**Stage 1 Road Safety Audit
Phase 1 Residential Development
Ballykeeran Gardens, Cornamaddy,
Athlone, Co. Westmeath**

Client:	Ballymore Group
Document No:	251416-ORS-XX-XX-RP-TR-13g-001_S1_RSA

This report documents the findings of a Stage 1 Road Safety Audit (RSA) carried out with respect of the proposed Phase 1A Residential Development Ballykeeran Gardens in Cornamaddy, Athlone, Co. Westmeath

Problem No.02: Unclear Tie in Between Development to North and Proposed Development Access Roads

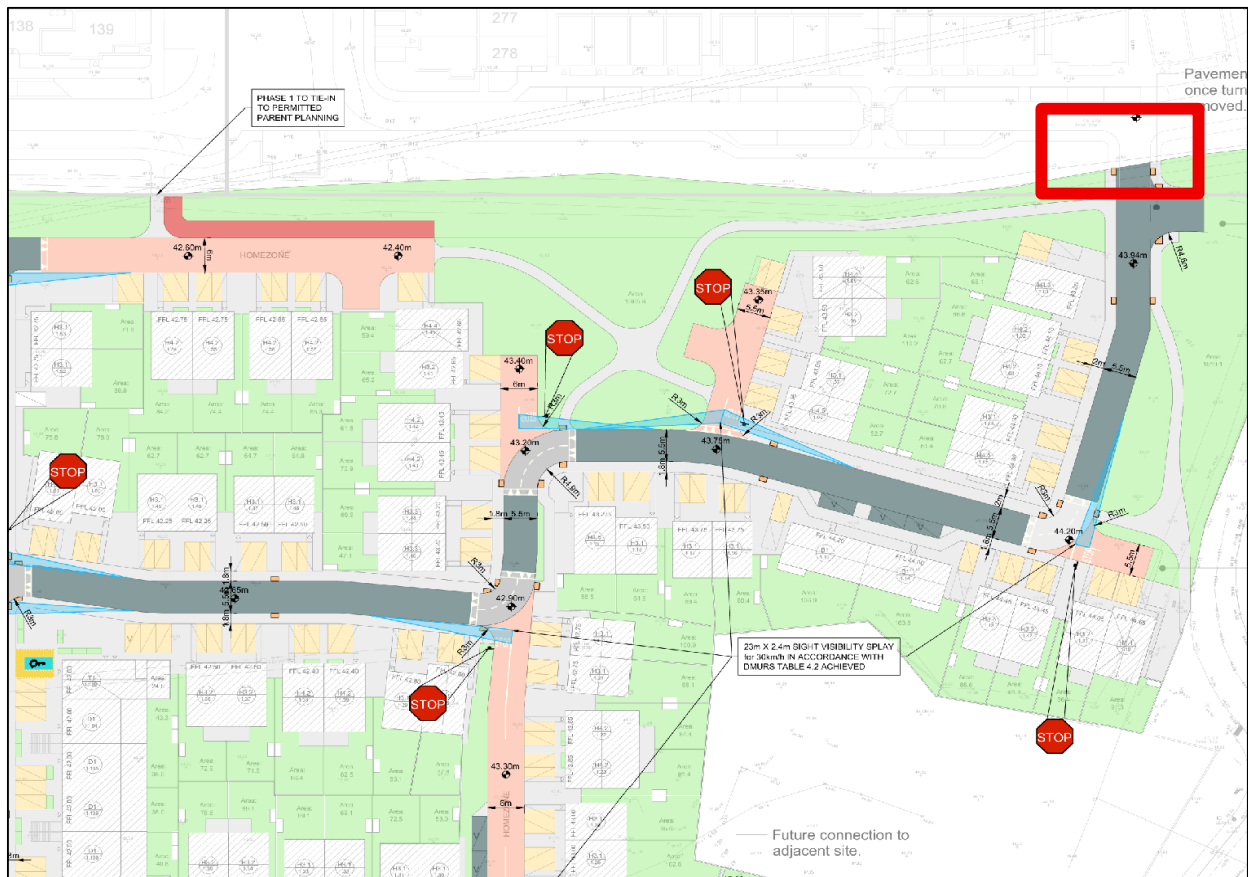
The drawing indicates a connection between the existing development road network and the proposed Phase 1 roads; however, the detailed junction arrangement, priority control, carriageway alignment and transition between the existing and proposed layouts are not clearly defined on the submitted drawing. This may create uncertainty for drivers regarding right-of-way and vehicle positioning, particularly during the early occupation phases of the development and while construction traffic is present. The lack of a clearly legible junction form could increase the risk of side-impact and turning collisions.

Problem No.03: Tie-in to Footpaths and Cycle Tracks to Existing Infrastructure to East and Development to North

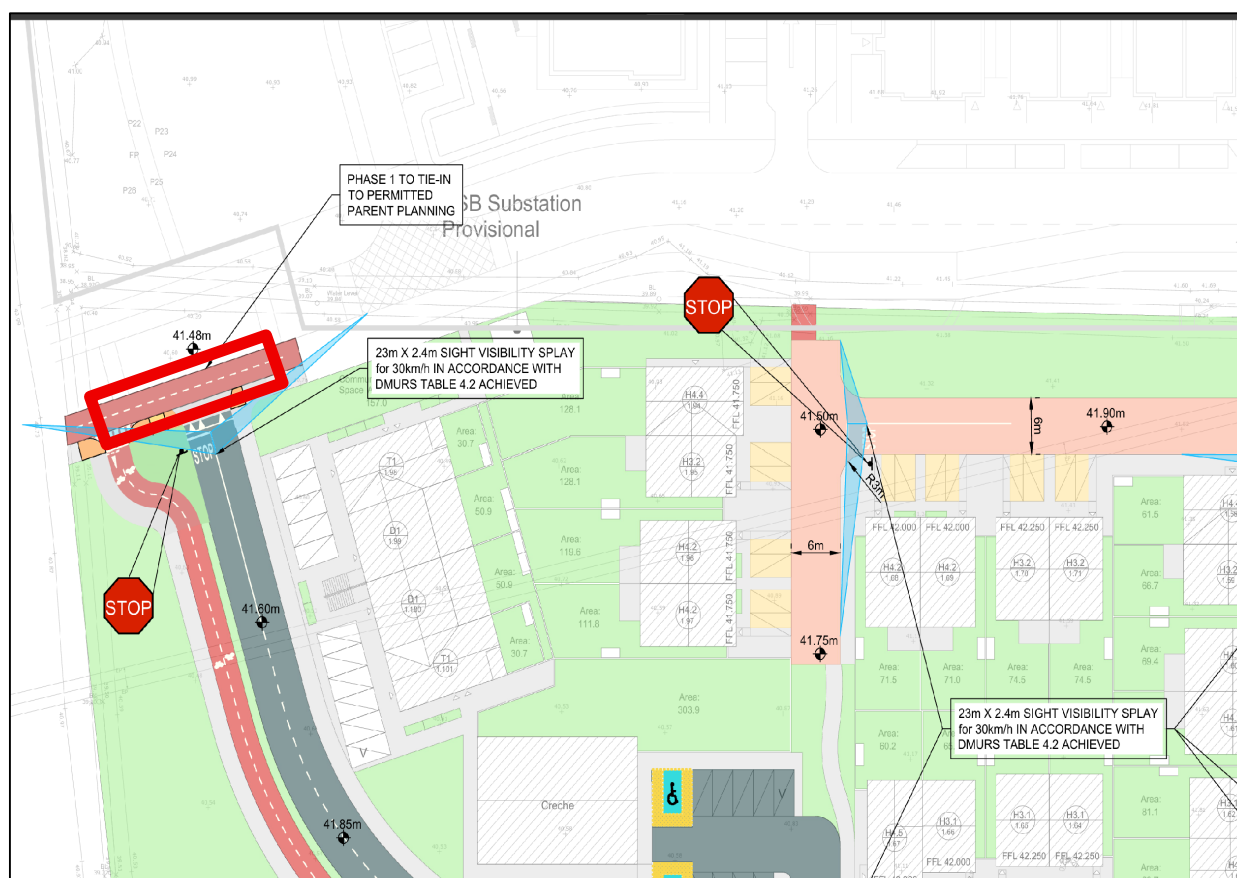
The submitted layout does not clearly demonstrate how the proposed footpath and cycle route network will tie into existing pedestrian and cyclist infrastructure or the future development lands to the north. The lack of a clearly defined connection strategy may result in pedestrians and cyclists being directed onto carriageways, crossing undesigned locations, or using informal routes. This could reduce network permeability and increase the potential for conflict between vulnerable road users and vehicles, particularly when future phases of development are delivered.

The design team should ensure clear details of how pedestrian and cyclist facilities will connect to existing and future infrastructure beyond the site boundary. Continuous routes should be provided with appropriate widths, surfacing, priority arrangements and crossing facilities. Any temporary termination of footways or cycle routes should be designed to safely accommodate users until future connections are delivered.

Problem No.07: Restricted Car Parking Spaces Resulting in Difficult Manoeuvring

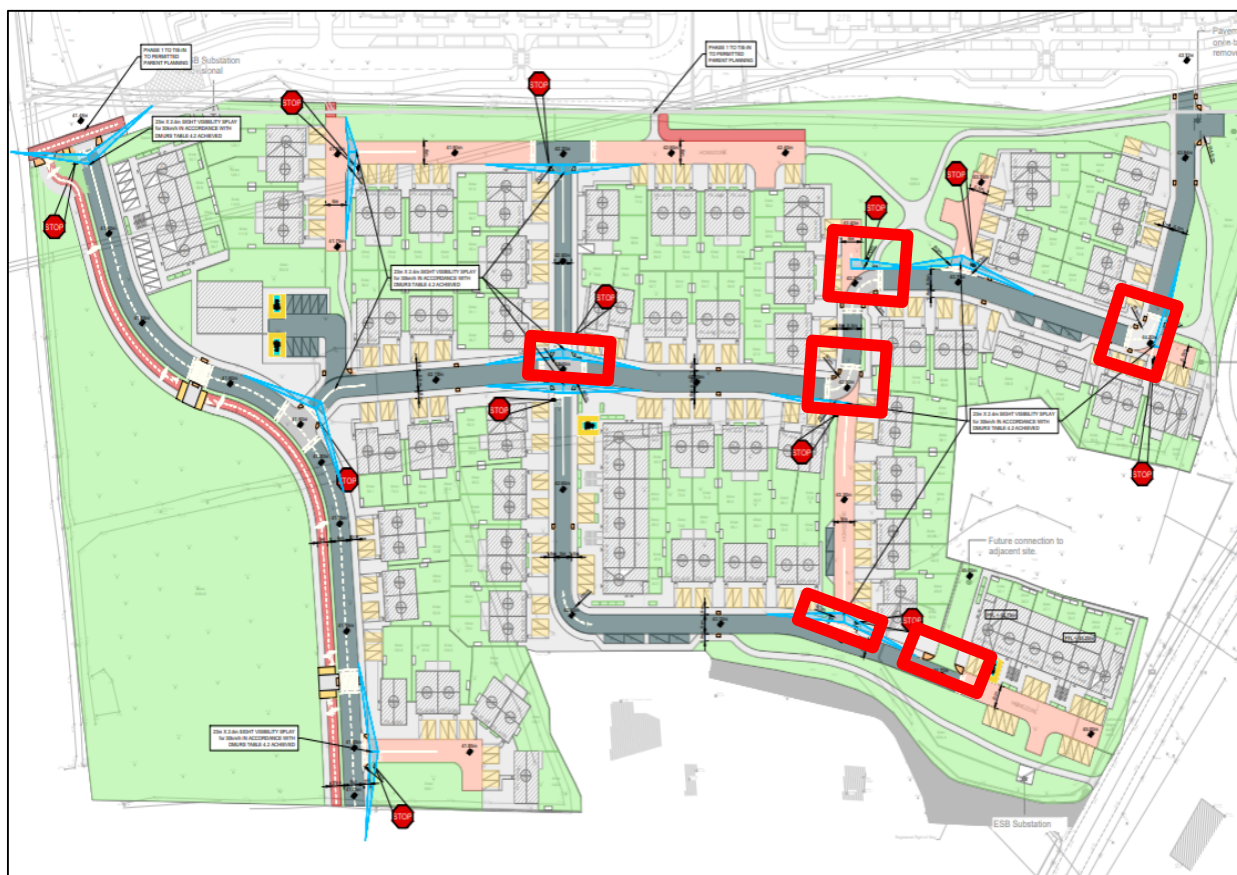
The audit team notes from the drawings provided that a number of the proposed parking spaces appear constrained by their location and surrounding geometry. It is not clear that sufficient manoeuvring space is available for all vehicle types to safely enter and exit the spaces. Restricted parking layouts may result in drivers undertaking multiple manoeuvres or reversing excessive distances to access the carriageway. This may increase the likelihood of vehicle-to-vehicle collisions, particularly in areas with frequent parking turnover. Furthermore, reversing vehicles may not readily detect pedestrians, cyclists, or other vulnerable road users travelling behind the vehicle, thereby increasing the risk of injury collisions.

The design team should ensure that adequate manoeuvring space is available for vehicles to safely enter and exit all parking spaces. Vehicle tracking should be undertaken where necessary to confirm suitability. Parking layouts should minimise the need for excessive reversing movements and ensure adequate visibility is available between drivers and pedestrians, cyclists, and other road users. Any constrained spaces should be redesigned to improve accessibility and user safety.

P07	Y	Y	(Refer to ORS drawing 730-733)	
P08	Y	Y	(Refer to ORS drawing 700)	
P09	Y	Y	(Refer to ORS drawing 700)	
P10	Y	Y	Utility Manhole covers will be relocated outside of crossing zone.	
P11	Y	Y	To be provided at detailed design stage.	
P12	Y	Y	Bollards provided as per the parent permission.	
P13	Y	Y	To be provided at detailed design stage.	
P14	Y	Y	To be provided at detailed design stage.

Problem No.09: Private Parking Spaces Reversing into Priority Junction to Exit

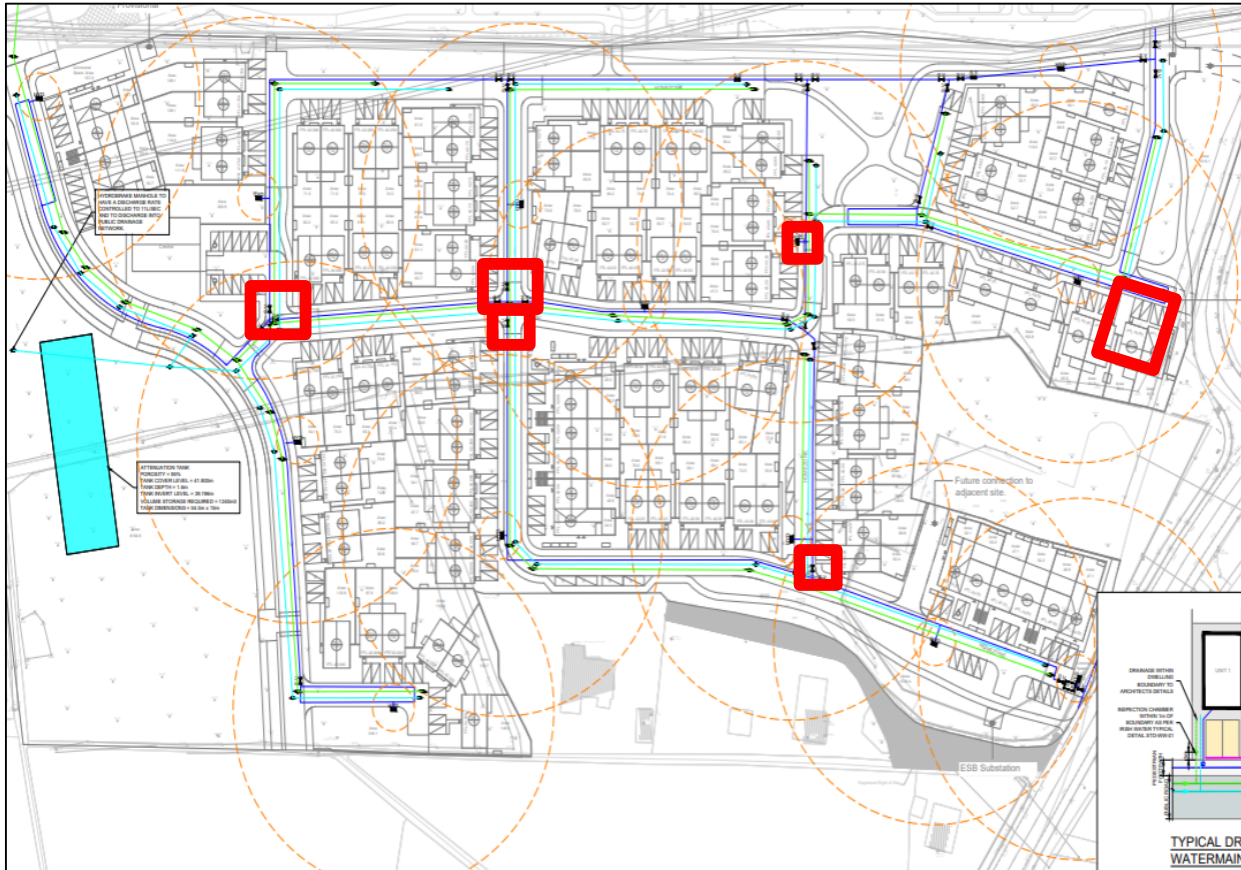
The audit team notes that a number of private parking spaces appear to be located in close proximity to priority junctions, such that vehicles may be required to reverse from private driveways directly into, or immediately adjacent to, the junction area before proceeding onto the carriageway. Drivers reversing from these spaces may have restricted visibility of approaching traffic, pedestrians and cyclists, particularly where their attention is focused on manoeuvring their vehicle. Equally, drivers approaching the junction may not expect a vehicle to emerge in a reversing movement from a private parking space. The proximity of these manoeuvres to the junction can increase decision-making demands on road users and may result in vehicle-to-vehicle or vehicle-to-pedestrian conflicts. Vulnerable road users, including children and cyclists, may be particularly difficult to detect during reversing manoeuvres.

The design team should ensure the layout of private parking spaces situated adjacent to priority junctions and seek to minimise the need for vehicles to reverse into junction influence areas. The designer should also demonstrate that appropriate visibility is available between reversing drivers and other road users.

Problem No.11: Absence of Cycle Track Signage Along the Cycle Track

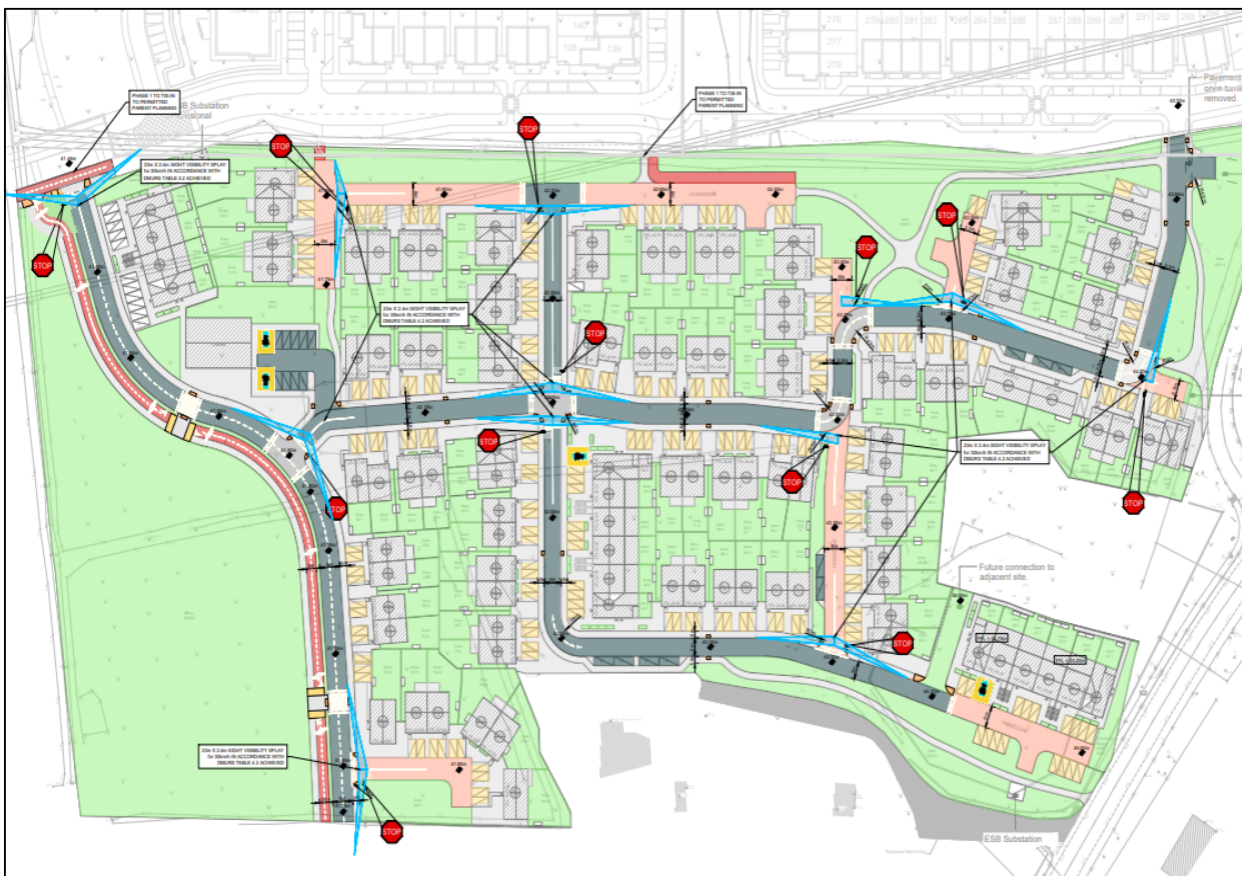
The audit team notes that no cycle track signage is indicated on the drawings provided. In the absence of dedicated signage along the cycle route, cyclists may be uncertain as to the intended route alignment, continuation of the facility, priority arrangements at crossings, and connections to adjacent phases of development or external cycle infrastructure. Furthermore, where cycle tracks run adjacent to pedestrian facilities or intersect with vehicular routes, the absence of signing may reduce awareness among other road users of the presence of cyclists. This may lead to uncertainty, route deviation, and an increased risk of conflicts between cyclists, pedestrians, and vehicles, particularly at junctions, crossing points, and points where the cycle route changes direction.

The design team should ensure the proposed cycle network has appropriate cycle signage strategy along the length of the cycle track. Signage should clearly identify the cycle route, assist with wayfinding, indicate route continuity, and reinforce priority arrangements where applicable.
